SUBJECT: Forwards proposed Tech Spec change re table notation (B) of
 Tech Spec Table 2.2-1 to provide lower limit to rate at
 which variable overpower trip setpoint decreases as reactor
 power decreased.

Subject: Palo Verde Nuclear Generating Station (PVNGS)
Units 1, 2 and 3
Docket Nos. STN 50-528 (License No. NPF-41)
STN 50-529 (License No. NPF-51)
STN 50-530 (License No. NPF-65)
Proposed Technical Specification Change - Variable
Overpower Trip Function
File: 87-A-056-026; 87-F-005-419.05

FIGURE 1
OPERATION OF THE VOPT REACTOR TRIP

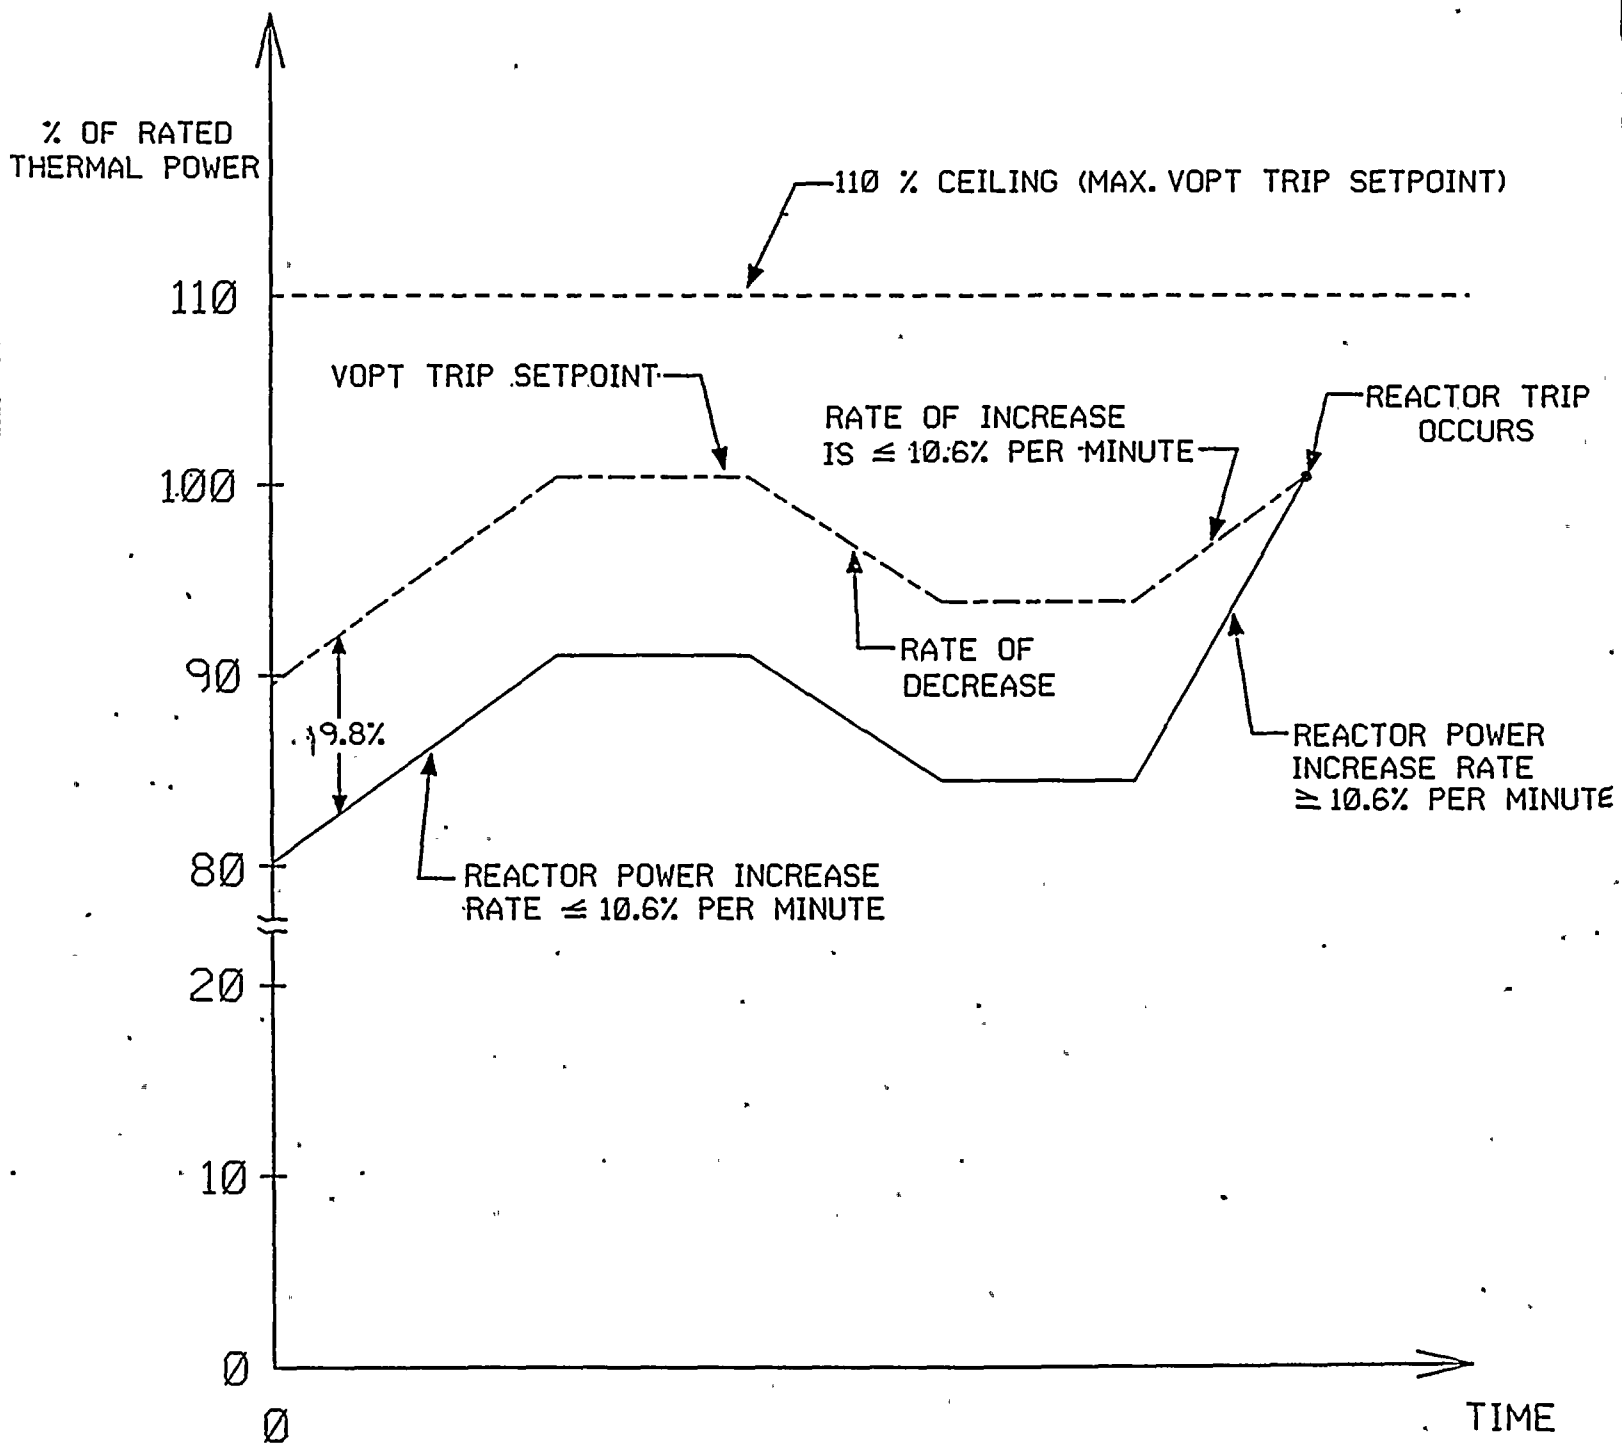
The behavior of the VOPT trip function is shown in Figure 1. The first part (beginning at time = 0) of Figure 1 shows the behavior of the VOPT trip setpoint during normal reactor power increases where the rate of power increase is less than or equal to 10.6% of Rated Thermal Power (RTP) per minute. For this case, the VOPT trip setpoint increases as reactor power increases while maintaining the band of 9.8% RTP between the trip setpoint and actual reactor power. For the second case, where reactor power is decreasing, the VOPT trip setpoint will track the reactor power downward while maintaining the band of 9.8% RTP. The rate of decrease of the VOPT trip setpoint will be limited to no slower than 5% RTP per second upon approval of this proposed Technical Specification change (currently there are no limits on the rate of decrease). For the third case of Figure 1, where reactor power is rapidly increasing at a rate greater than 10.6% RTP per minute, the reactor power is increasing faster than the VOPT trip setpoint is allowed to increase. This situation will eventually lead to a reactor trip as the reactor power either: i) exceeds the variable trip setpoint (as shown in Figure 1), or ii) exceeds the 110% RTP ceiling setpoint.

FIGURE 2

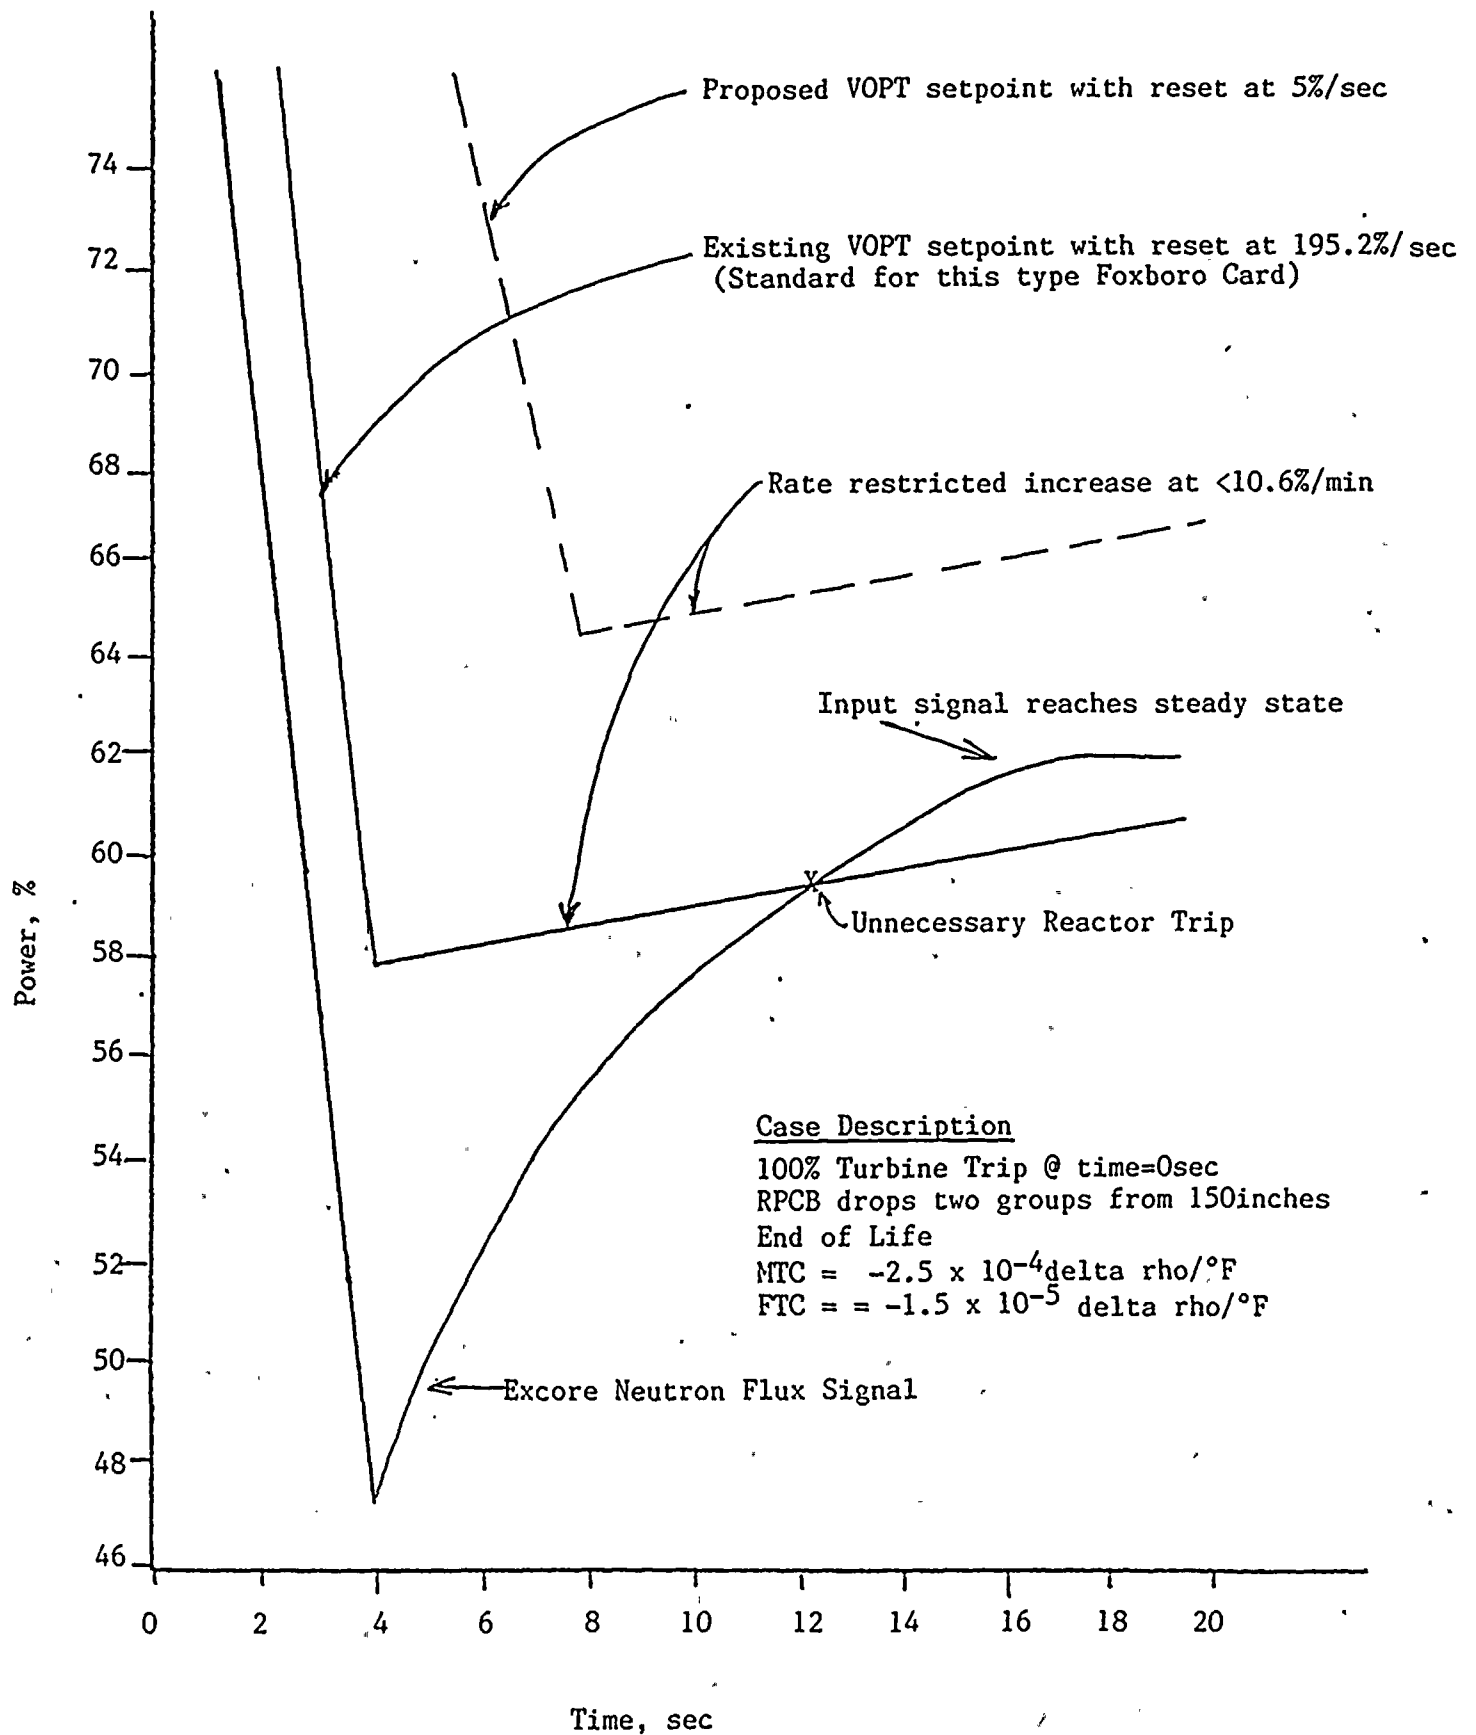
In order to avoid reactor trips during RPCS actuations, it is proposed that the VOPT trip function be modified to limit the rate at which the trip setpoint can decrease in response to decreasing reactor power. If the rate of decrease is set at 5% RTP per second, the results will be as shown on Figure 2. For this case, the VOPT trip setpoint remains above the reactor power following a RPCS actuation and no reactor trip signal is received.

FIGURE 3

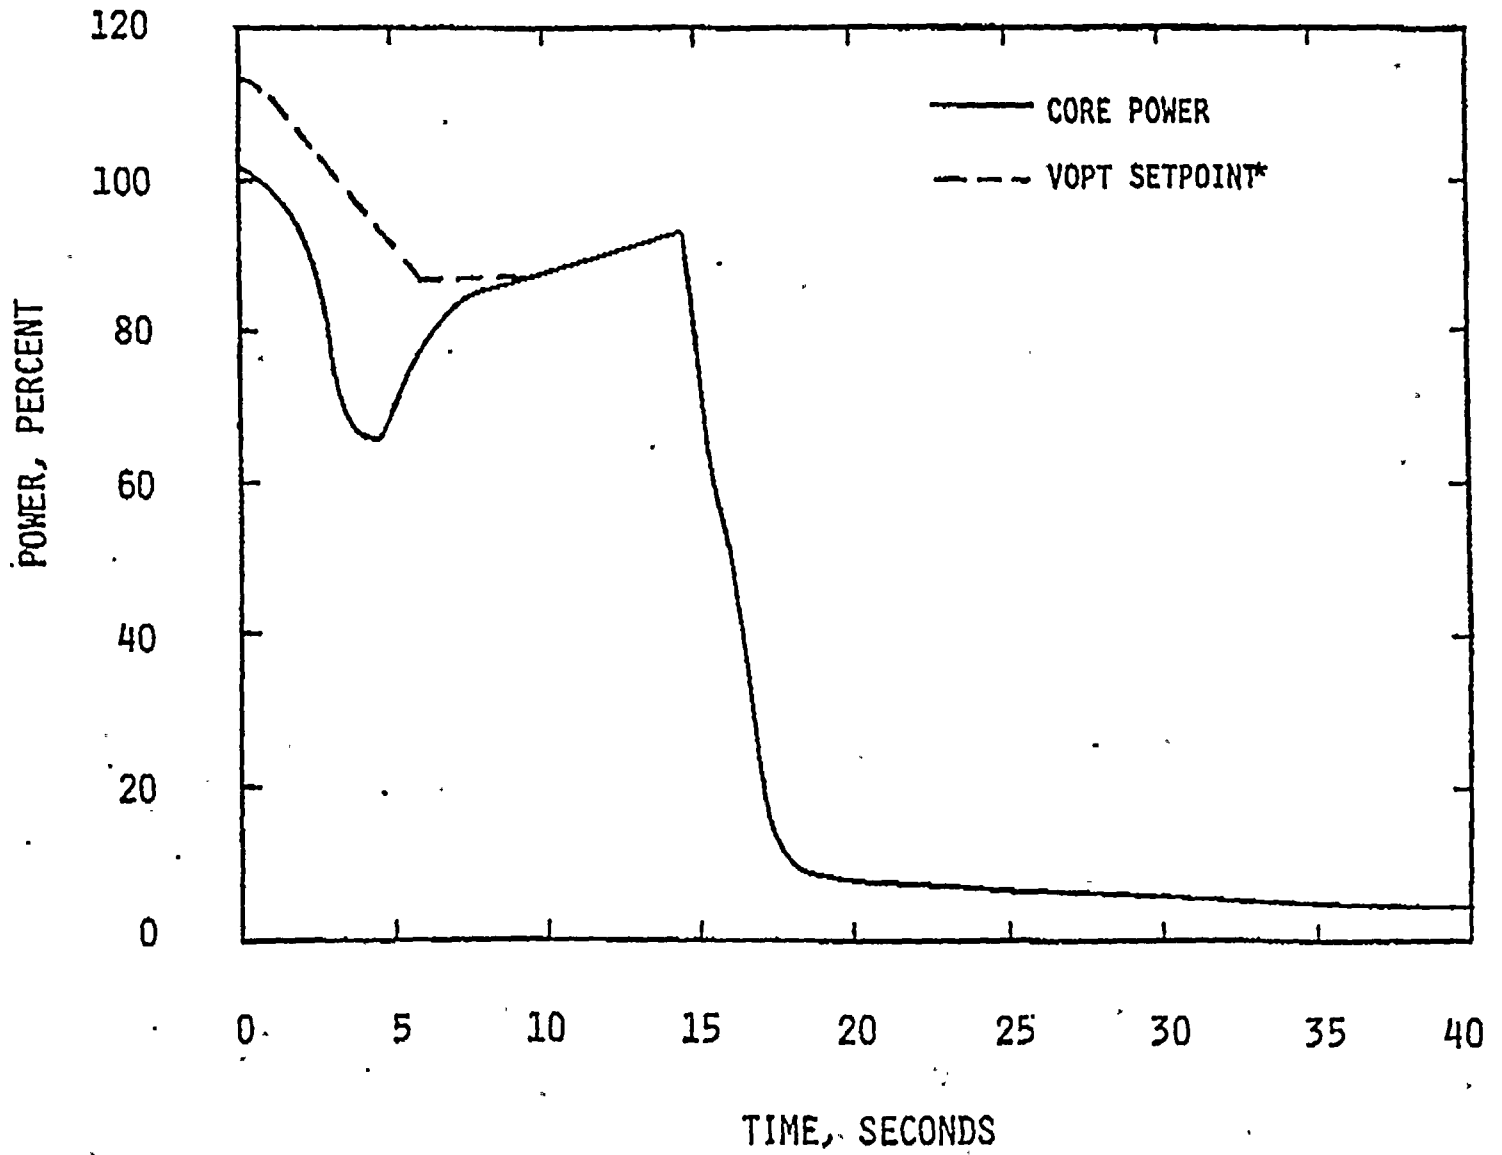
Figure 3 shows the response of both reactor power and the VOPT trip setpoint (assuming 5% RTP per second downward reset rate) during this abnormal reactor power cutback analysis. The sequence of events for this analysis are presented below. It should be noted that the minimum DNBR experienced during this analysis is 1.34 and the maximum linear heat rate is 15.6 kw/ft. Both of these values are acceptable because they are within the Specified Acceptable Fuel Design Limits (SAFDLs) on DNBR and linear heat rate.

* Note Trip assumed to occur later than that indicated by the intersection of the VOPT setpoint and calculated core power.
